REPORT OF THE ADVISORY COMMITTEE
ON FLOATING PLATFORMS

A. J. Tachmindji

November 1971

Report of the Advisory Committee
on Floating Platforms

Figure 2. JOINT DISCONTINUITY STRESSES IN A TWO-PART ASSEMBLY

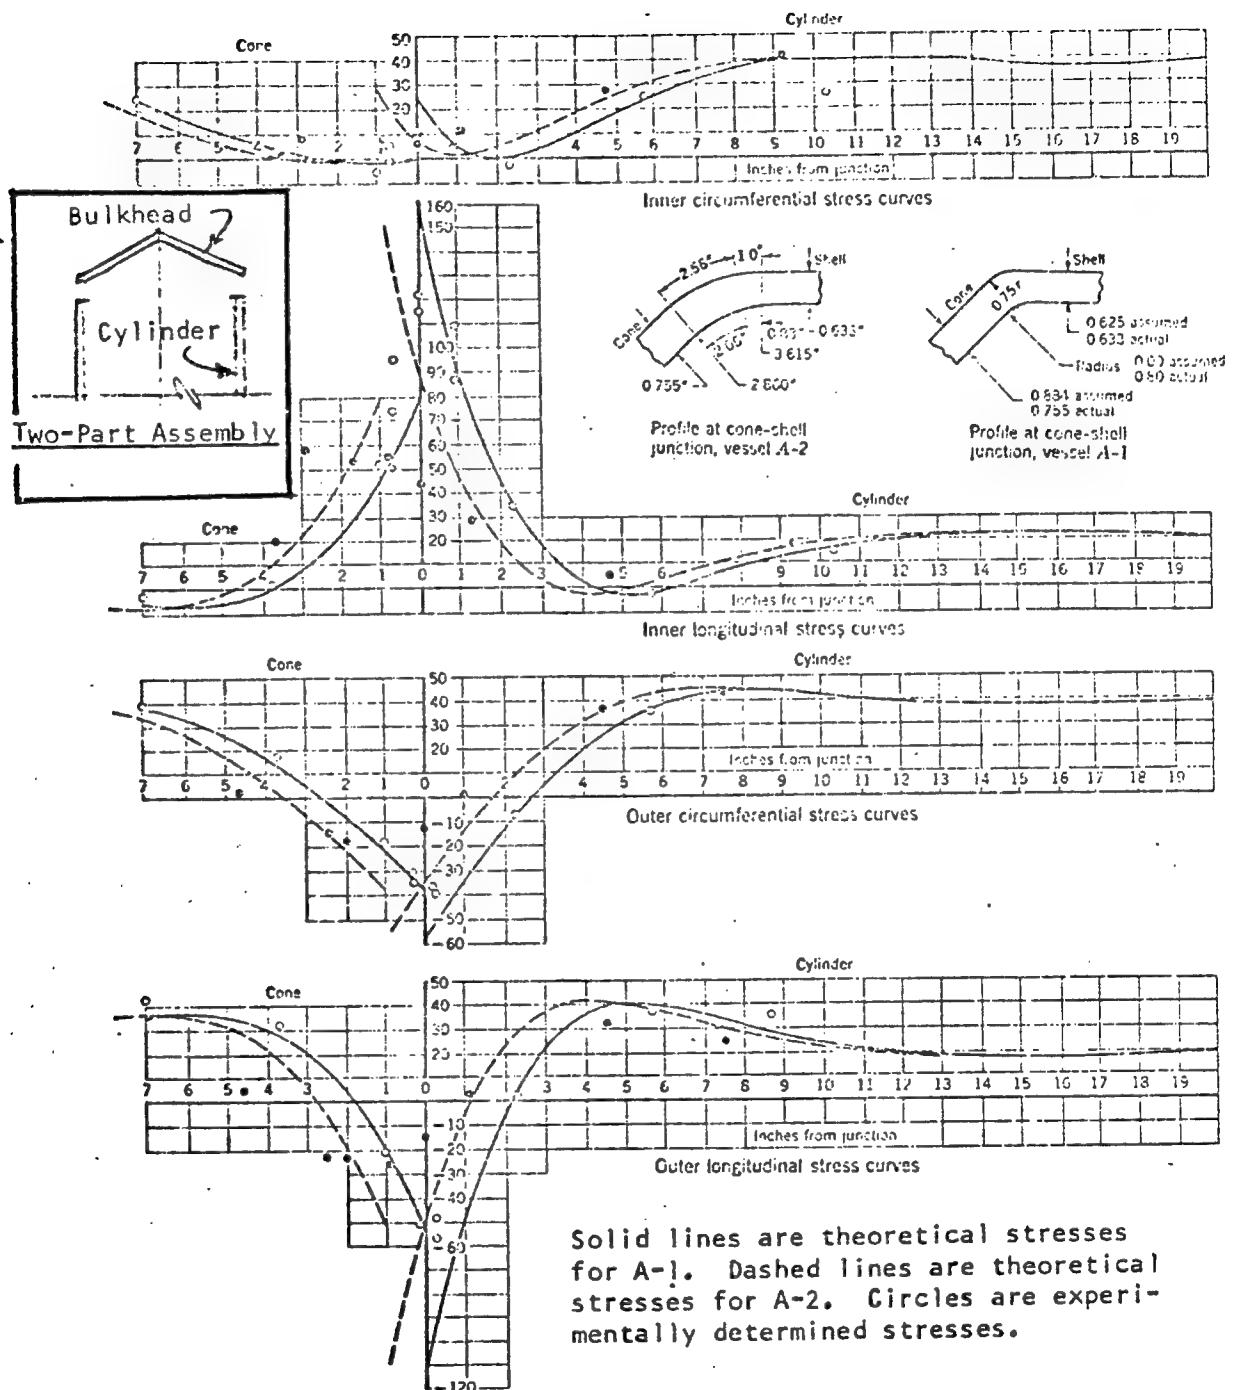
Figure 2 illustrates the effect of minimizing the abruptness of change in load direction for a two-part joint (bulkhead and cylinder). Figure 3 shows the results of a computer print-out of the stress distribution at the intersection of a three-part joint (cylinder-bulkhead-cylinder). The notations used in Figure 3 are:

Figure 3. JOINT DISCONTINUITY STRESSES IN A THREE-PART ASSEMBLY SUBJECTED TO -M BODY BENDING MOMENTS

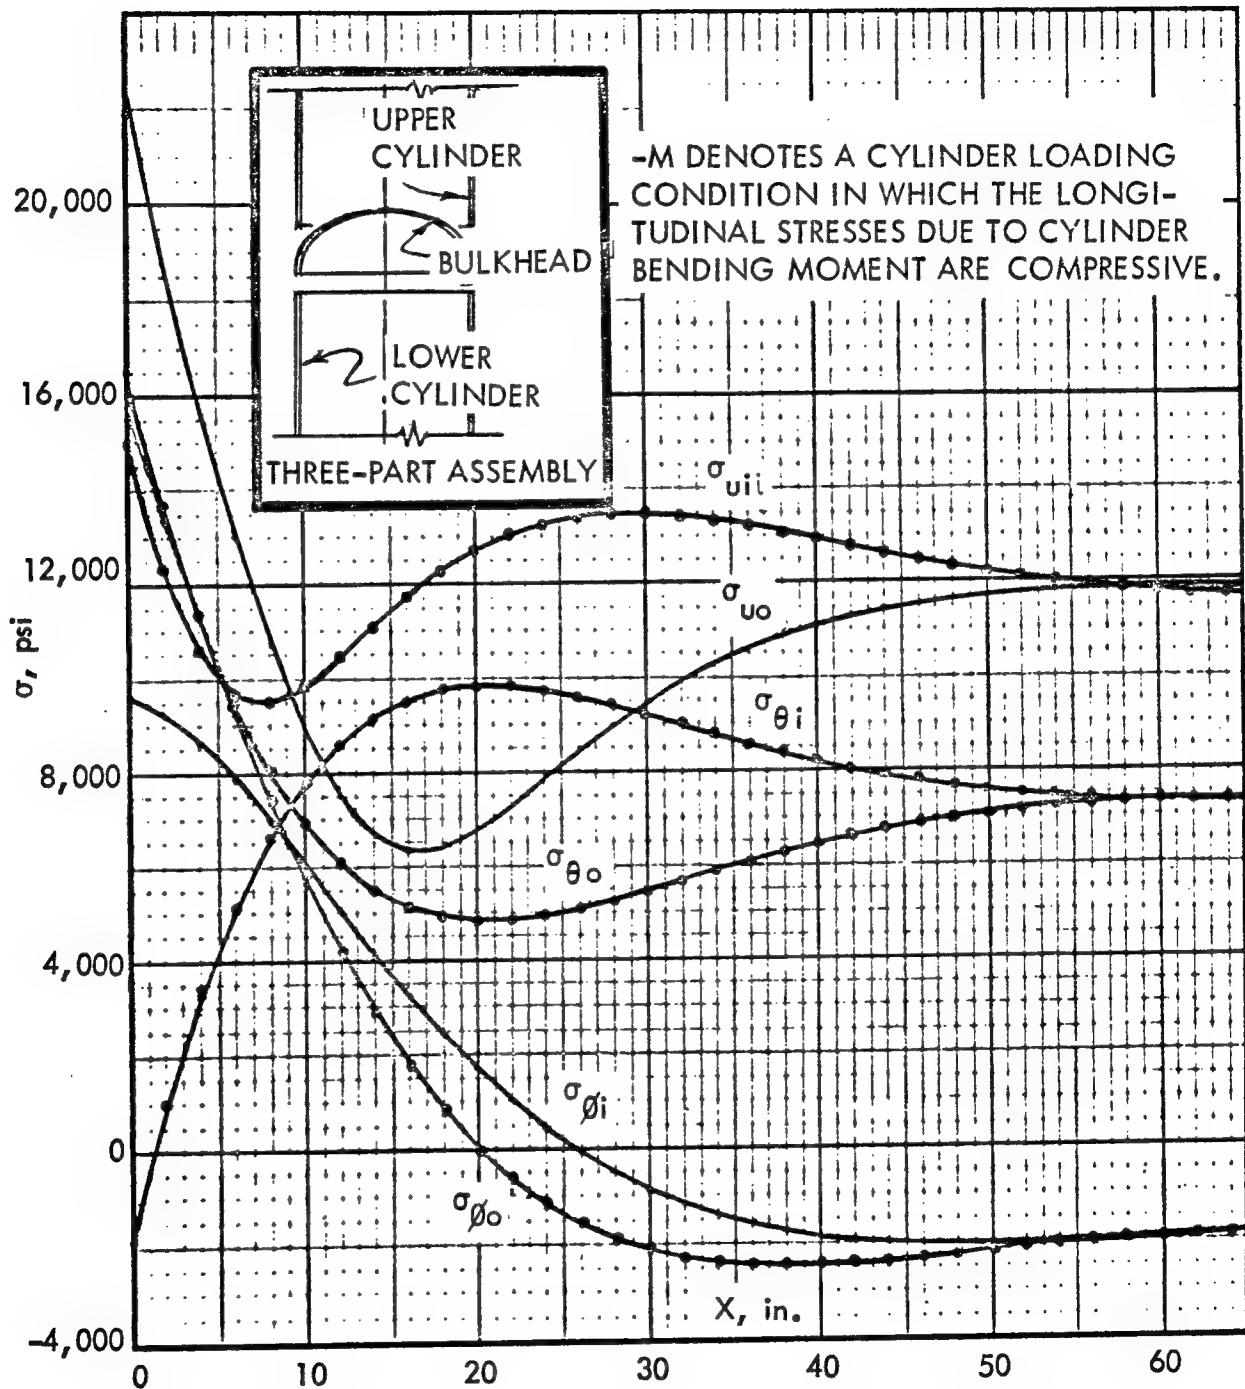
Changes in any one of the three rigidity parameters (flexural, extensional, shear) will greatly affect the stress distribution in the joint. The writer has the computer program used in this analysis and it is applicable to analyses of structures proposed for the ARPA Floating Platform.

Figure 4. MAXIMUM STRESS RATIO IN THE SHELL AT JOINT OF TWO-PART ASSEMBLIES

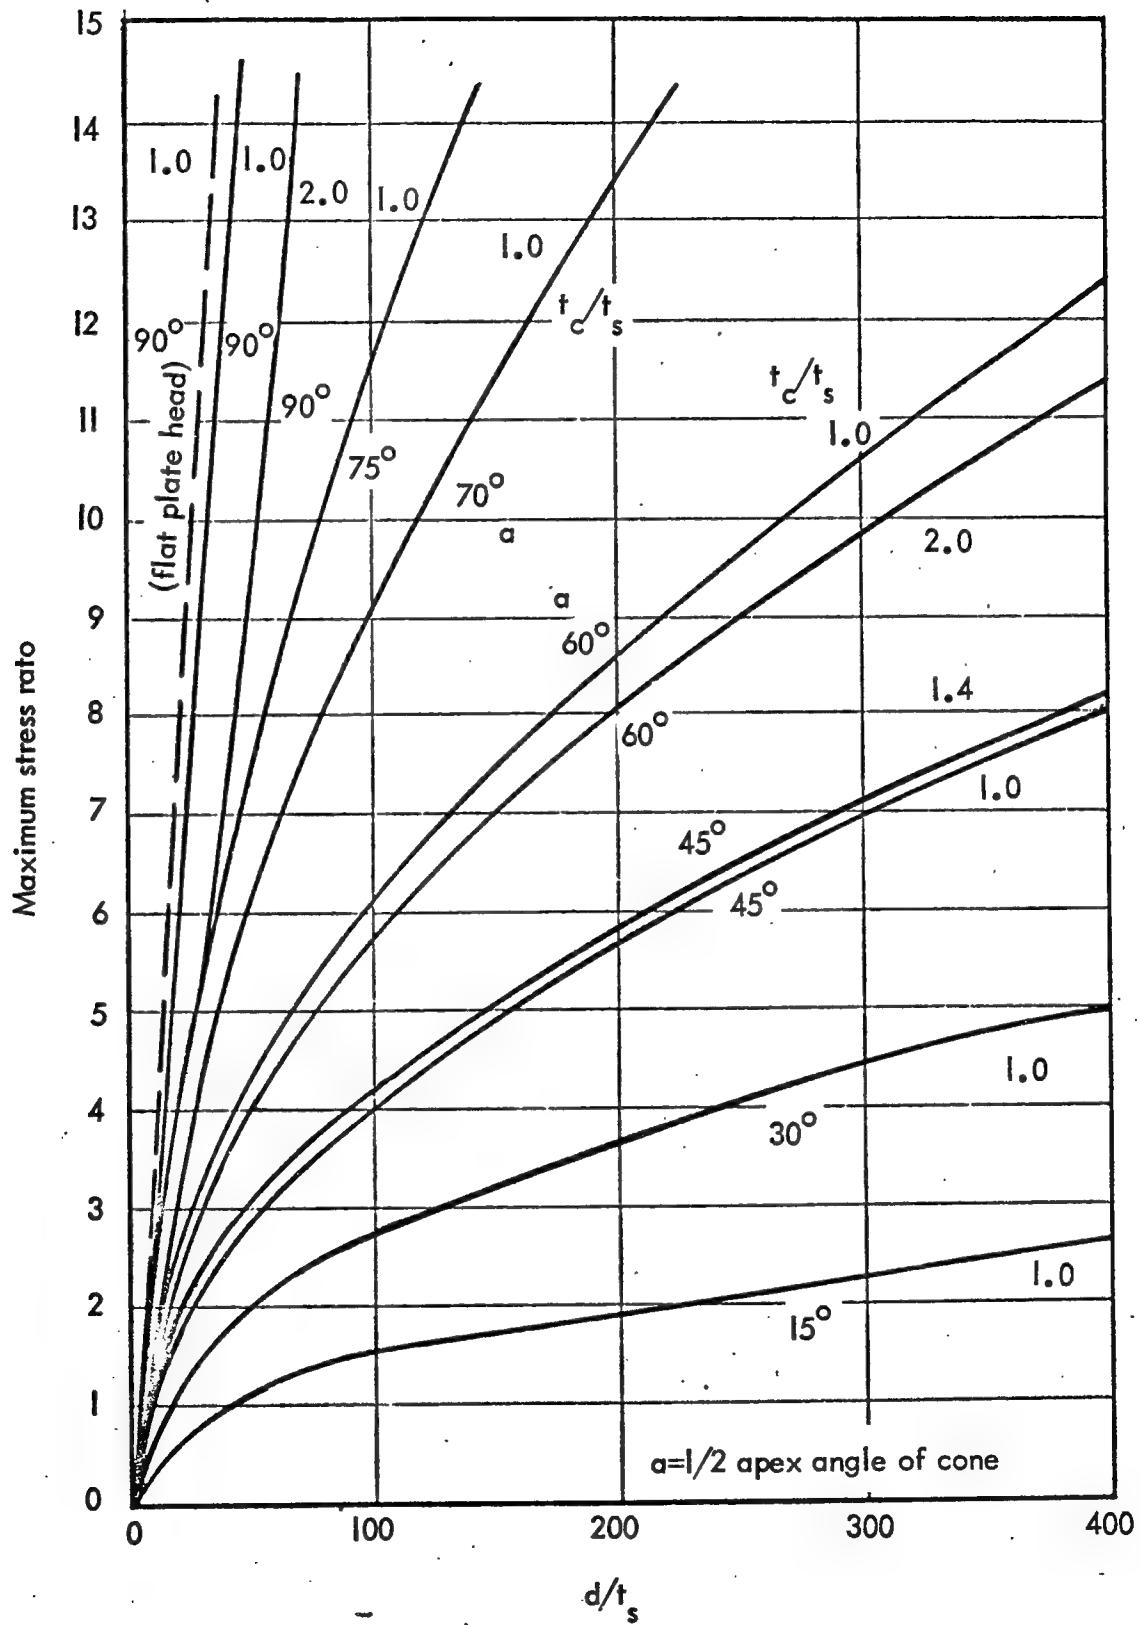
Figure 4 is a graph which shows the ratio of maximum stress to hoop stresses resulting from pressure loadings of tanks with various types of bulkheads. Note that a flat-plate bulkhead with $\alpha=90^\circ$ can develop a maximum stress ratio of 14.

Figure 5. MAXIMUM STRESS RATIO IN THE SHELL AT THE JOINT
IN FLAT-PLATE CLOSURES

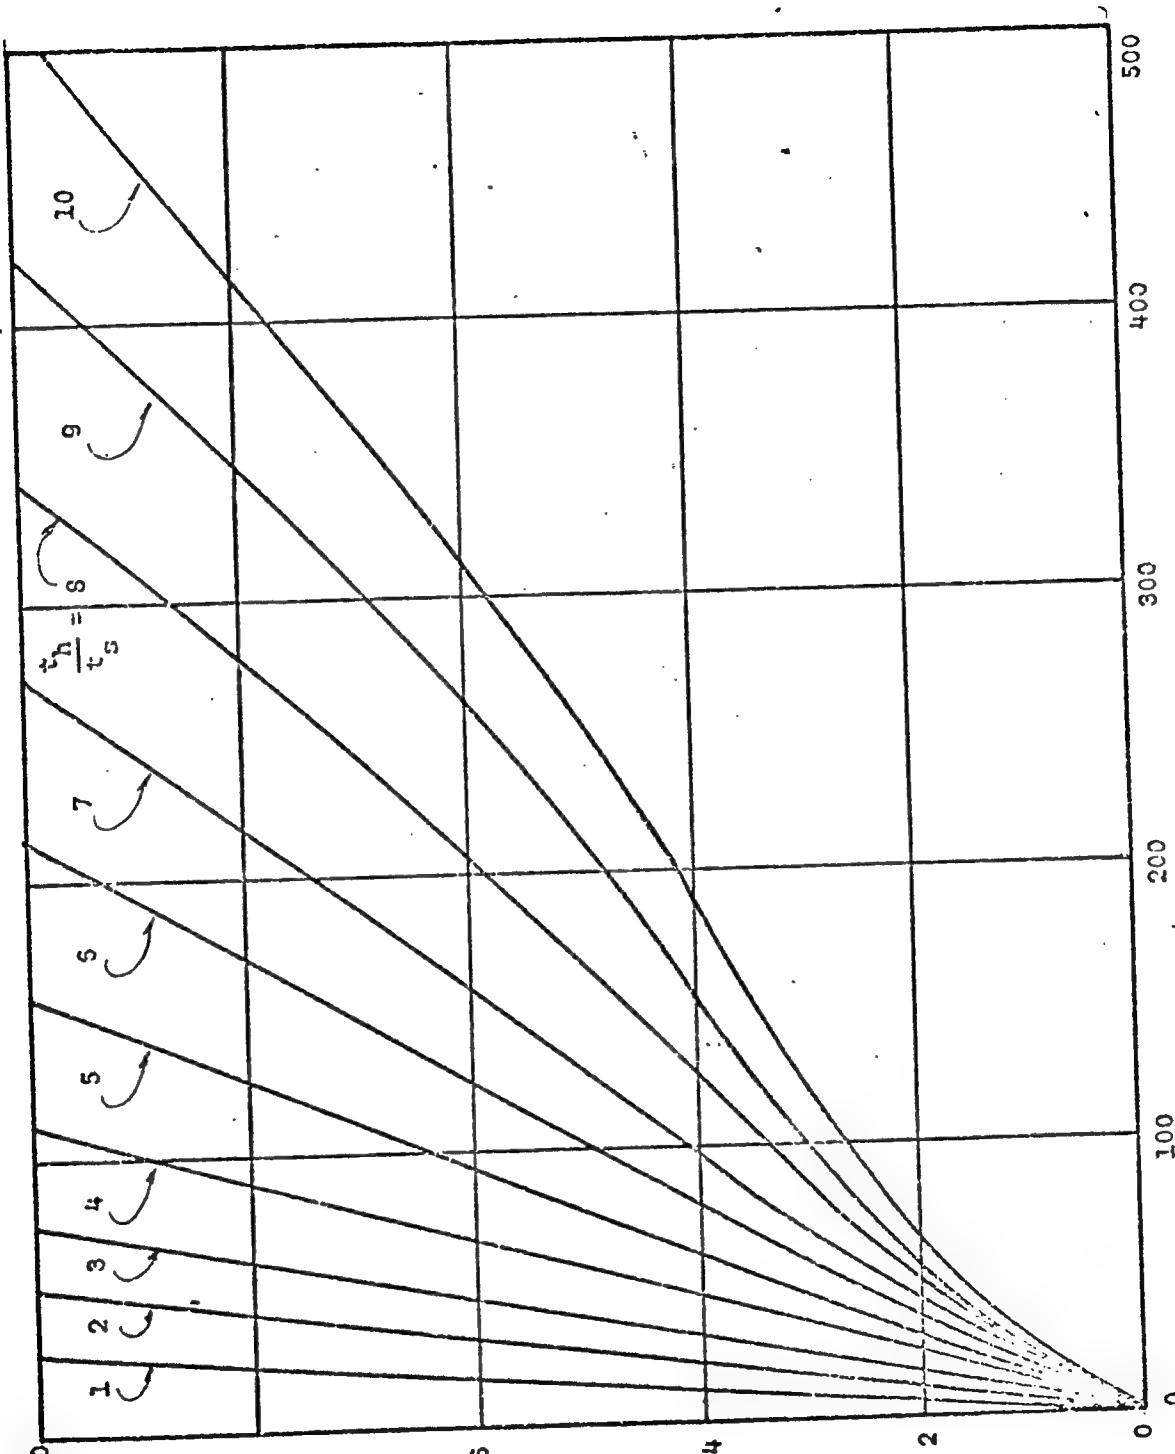
Figure 5 is similar to Figure 4, except that it pertains only to flat plates. Bulkhead and cylinder intersection joints can be analyzed both by numerical techniques and finite element modeling. If finite element models are utilized it is essential that flexural, extensional, and shear rigidities of the three intersecting shells be simulated. Many finite element models represent only one or two of these three rigidity properties, sometimes resulting in considerable error.
